Design Review Board Meeting

Tuesday, December 10, 2024, 2:30 PM

Dear Design Review Board,
Enclosed you will find our Final Submittal for the new Archeology Research Facility at Historic Mitchelville Freedom Park. This project is part of a larger previously approved Master Plan.

**Archeology Research Facility
40 Harriet Tubman Way - Final
Plan Set
December 10, 2024
DRB-001479-2024**

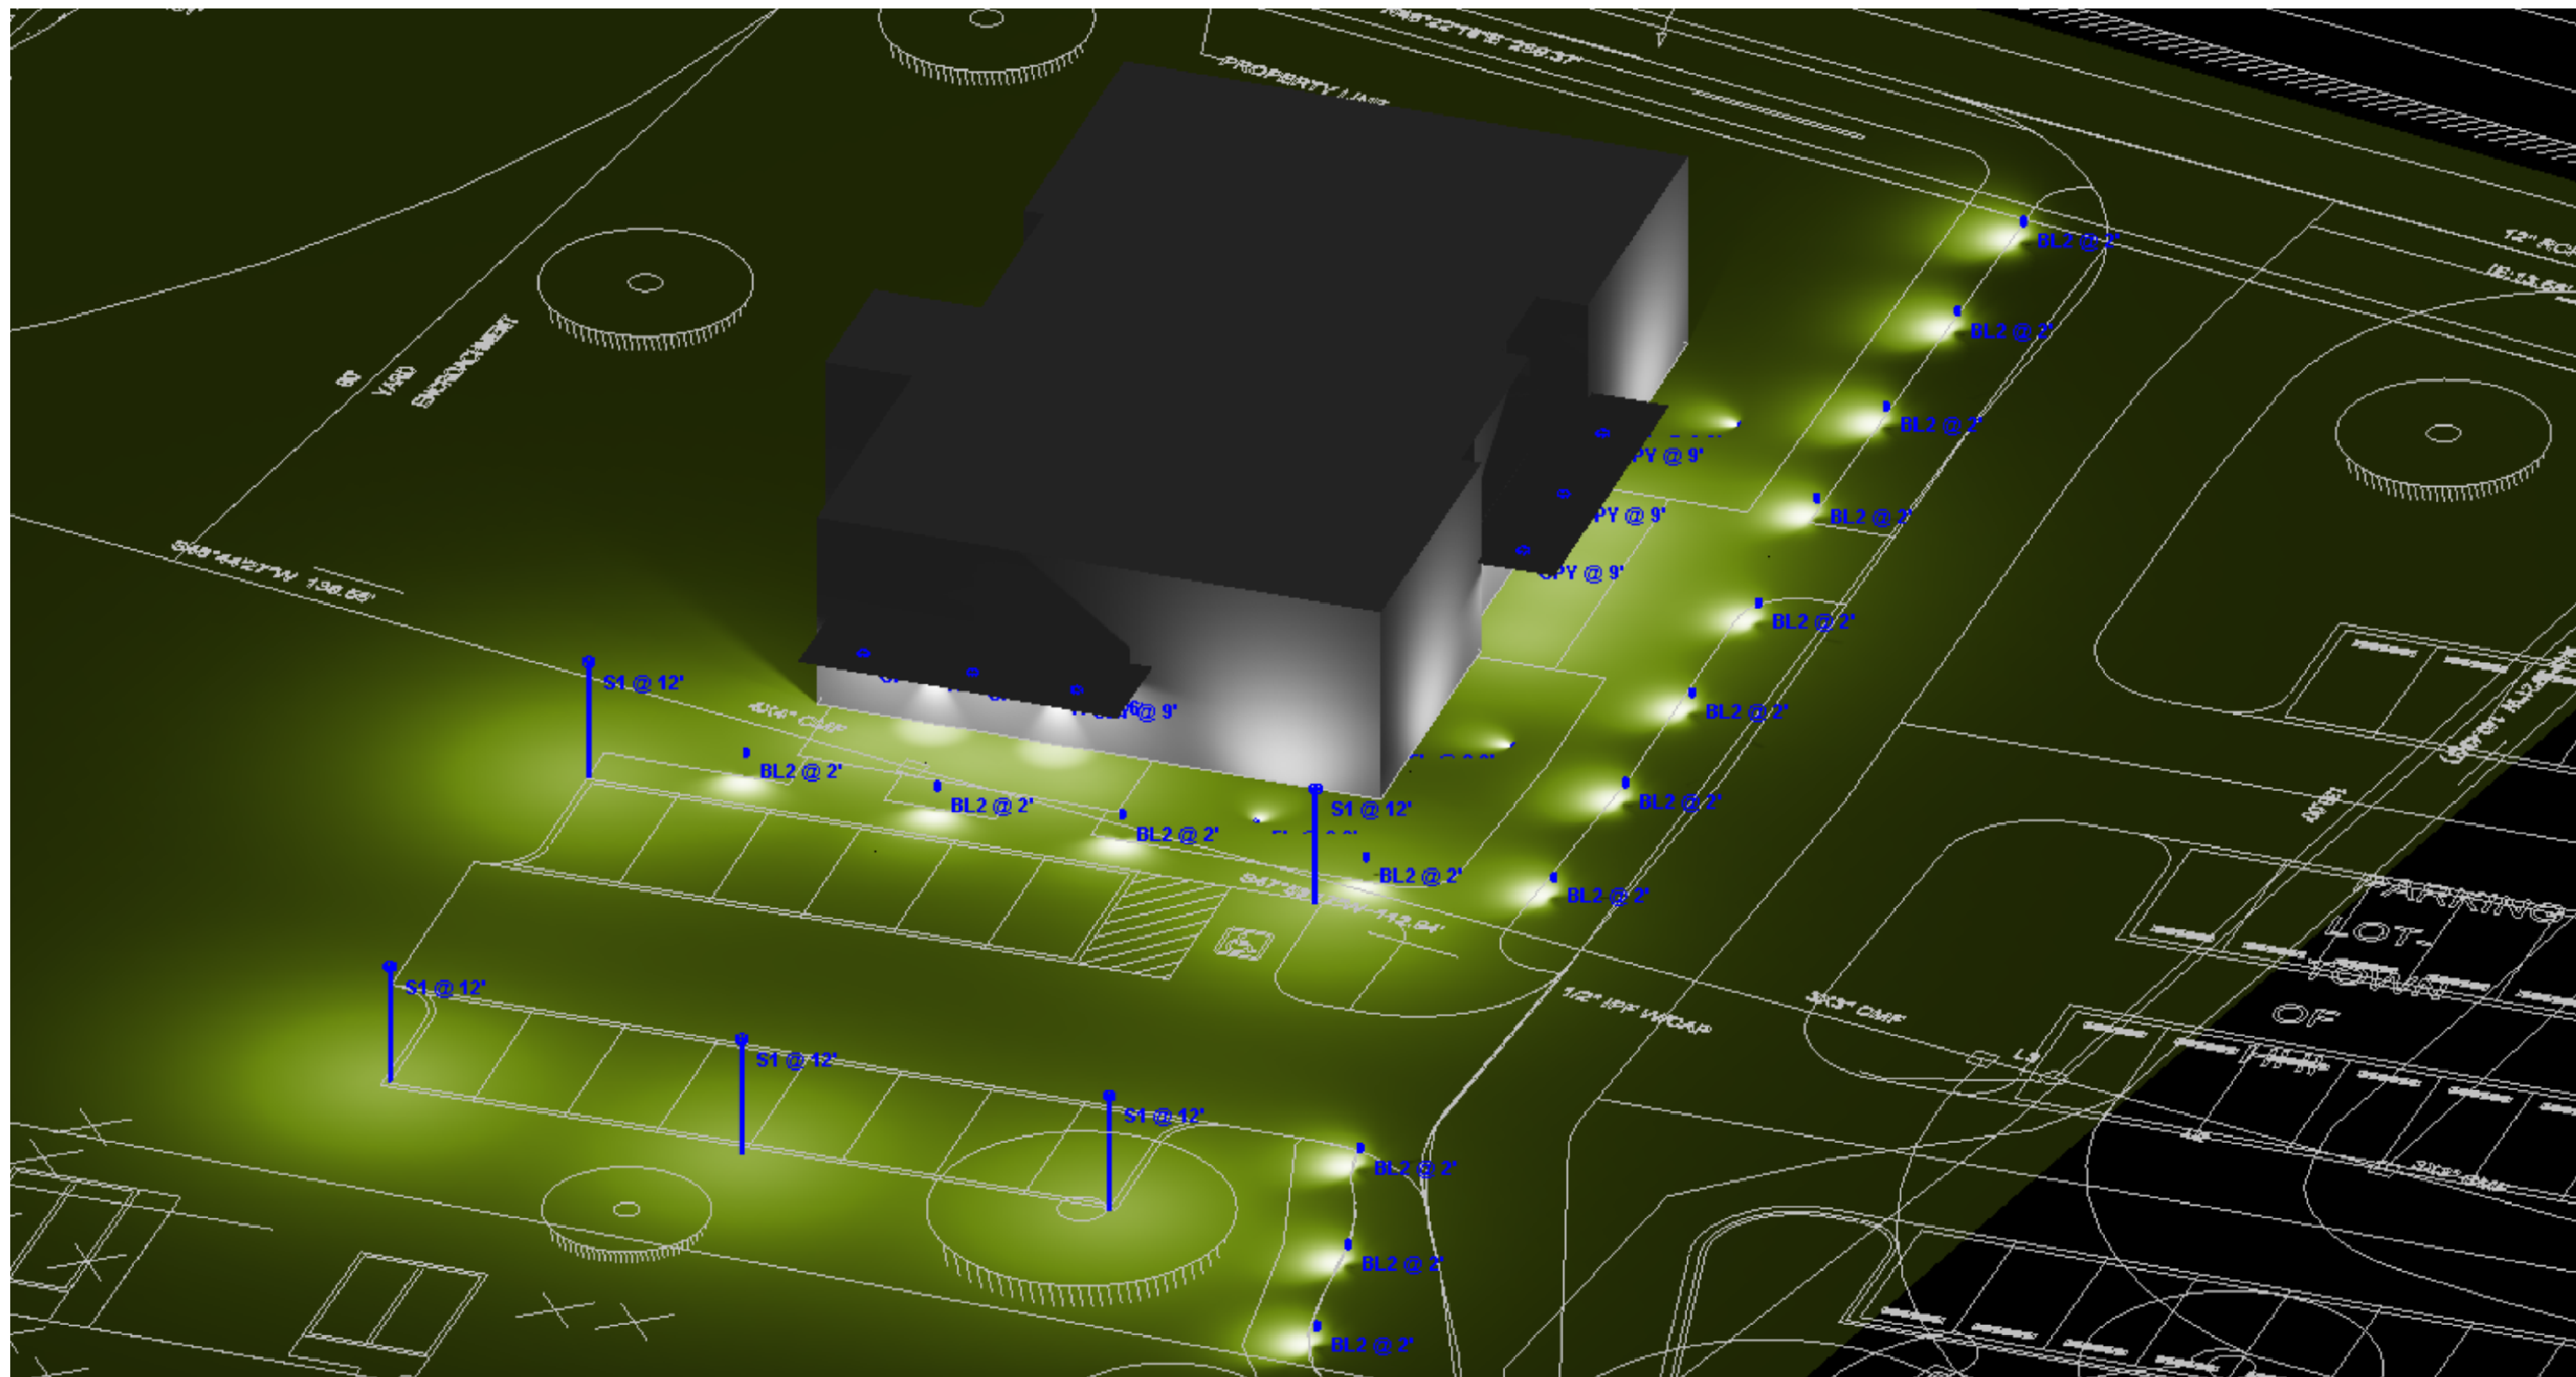
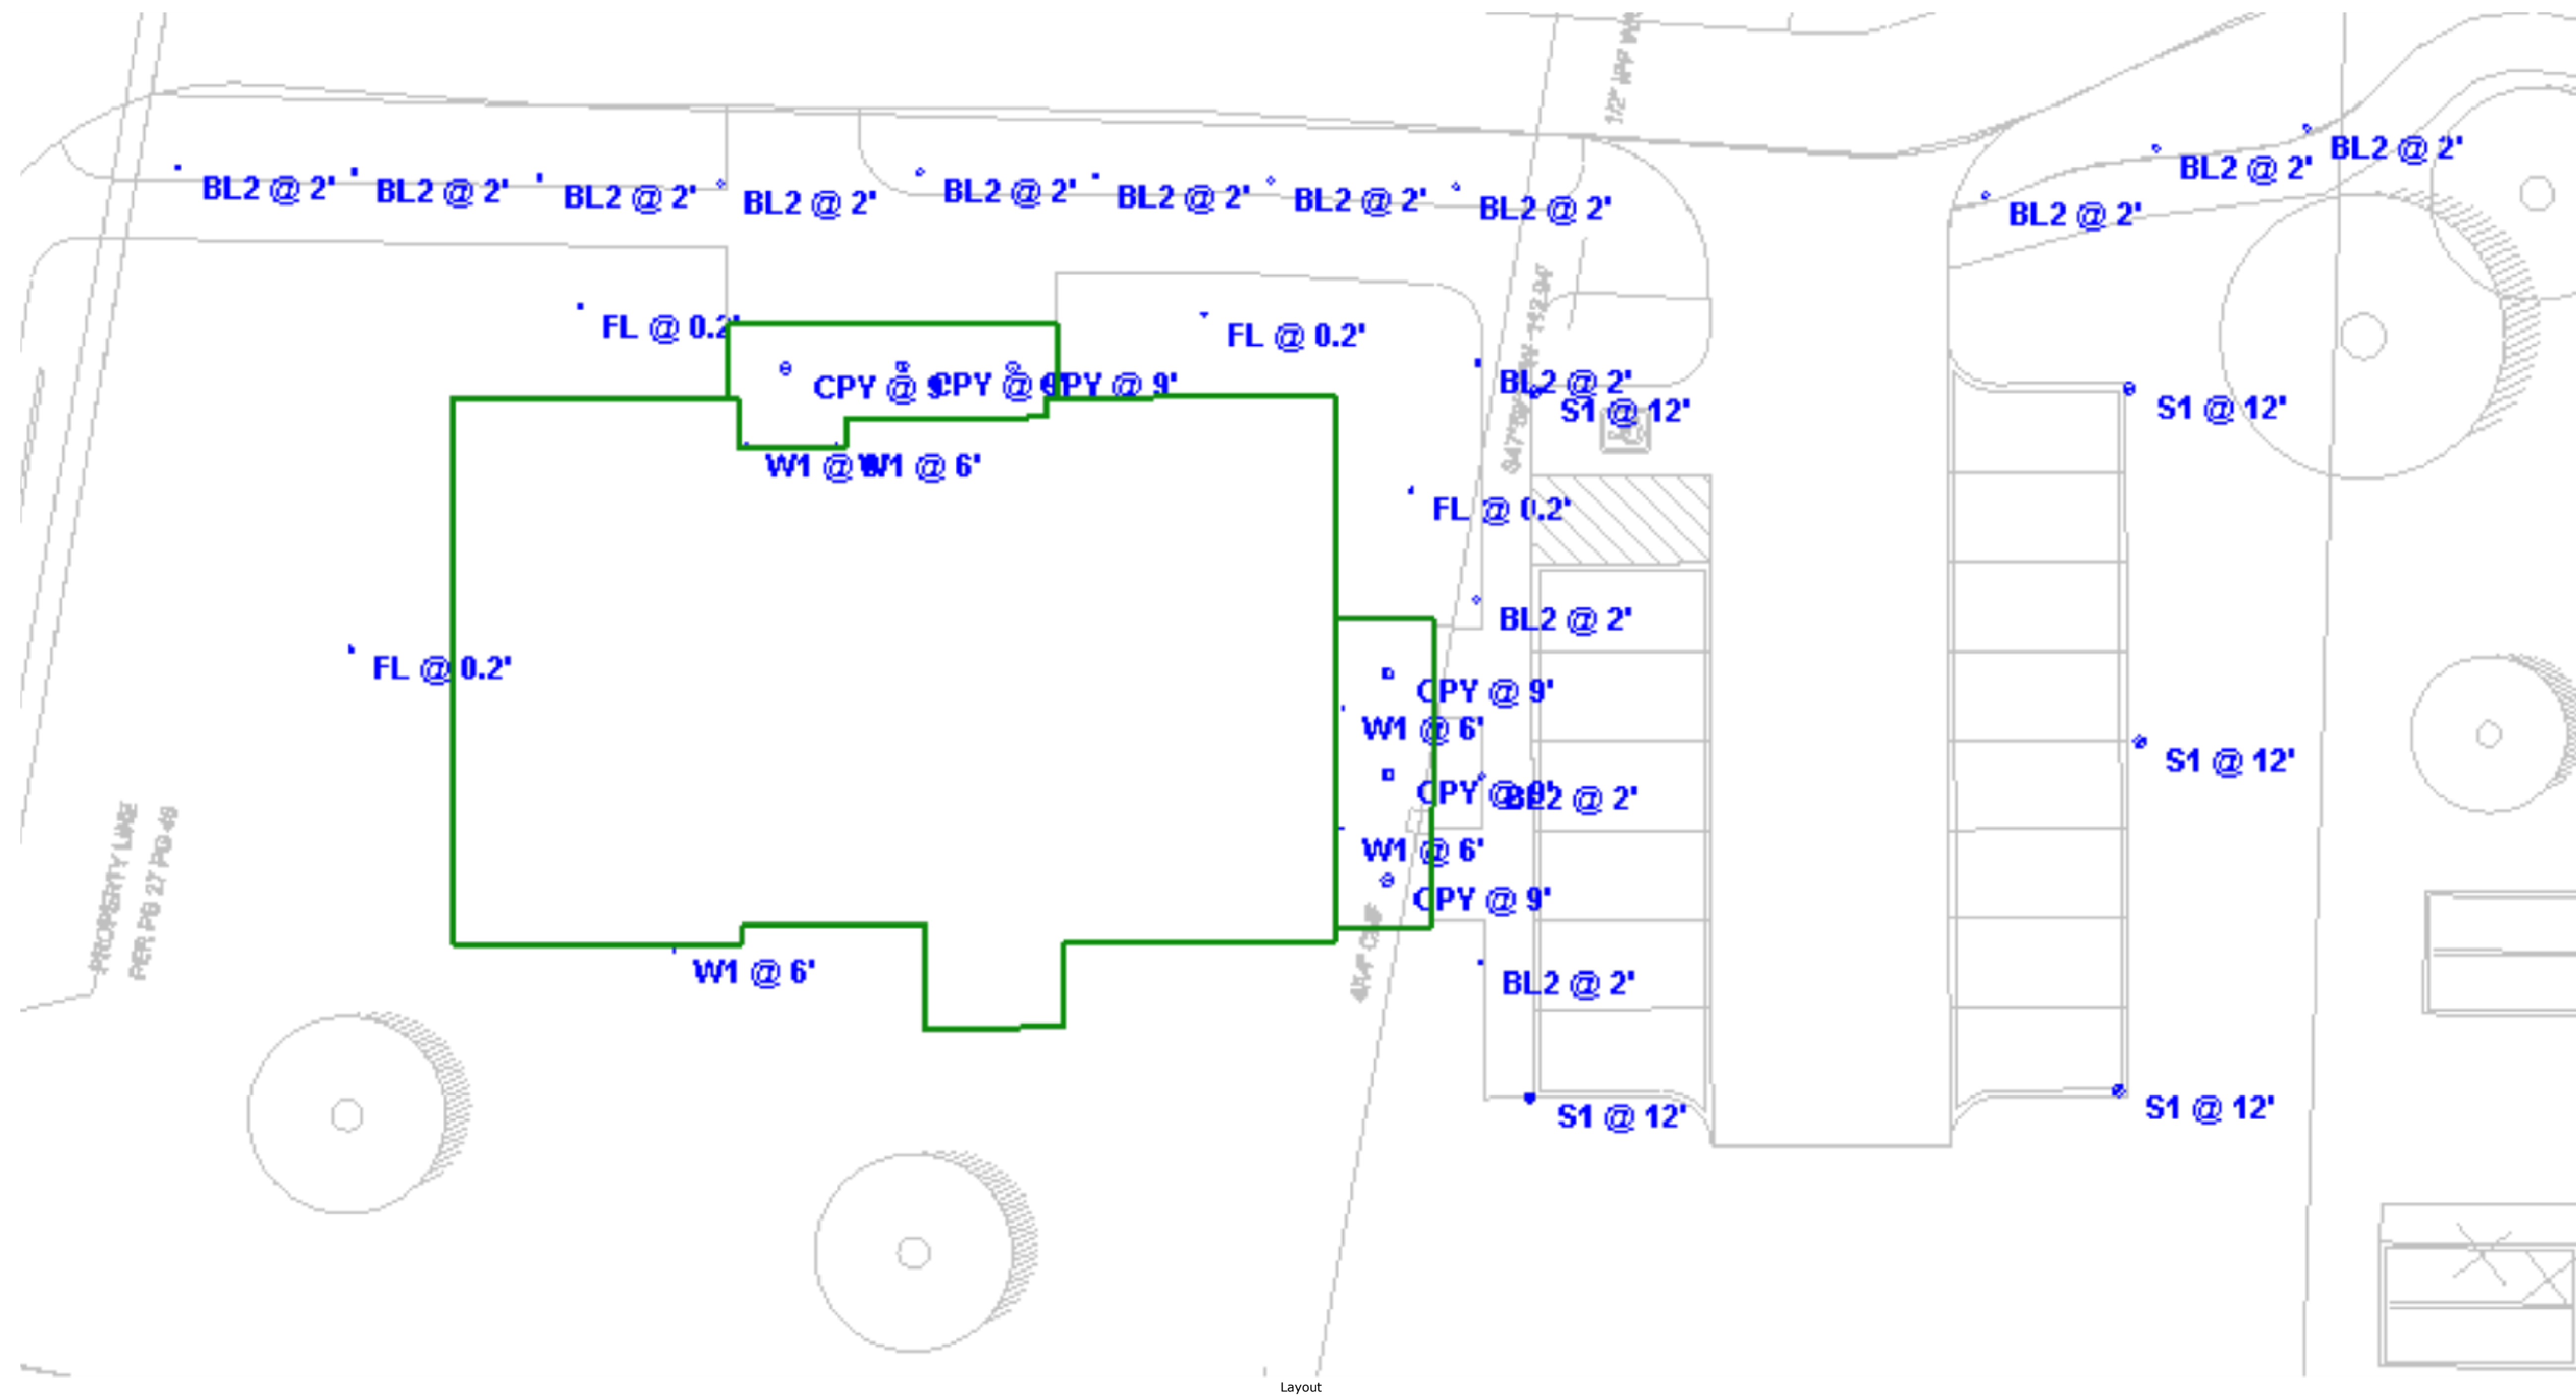
5. (ARCH/LAND) Site lighting, "study the foot candles, some areas look to have bright spots around the building" *The comment appears to have been referring to the wall sconces, which have a small concentration of light immediately below the fixture which dissipates rapidly just outside of the beam cone. See updated lighting plan, photometrics have been updated to reflect changes to the fixture locations.*

6. (ARCH/LAND) The photometrics are nice, but show a plan specifying where each of the light fixtures are located. *See updated lighting plan with fixture layout (page 2). Note fixture locations in bold blue font, which are keyed to the fixture schedule, ex: W1, BL2, CPY, S1.*

- *All Lighting Fixtures will be in a bronze finish with a 3000k light temperature, see selections on attached fixture cutsheets.*
- *The Lighting Fixture Schedule has been updated with images of the fixtures and a description.*
- *The lighting consultant had used the incorrect fixture for the bollard path lighting in the first submittal, this has been corrected. Note that there are now more bollard lights along the path in the updated plan.*
- *Lighting system will be managed by a programmable timer.*
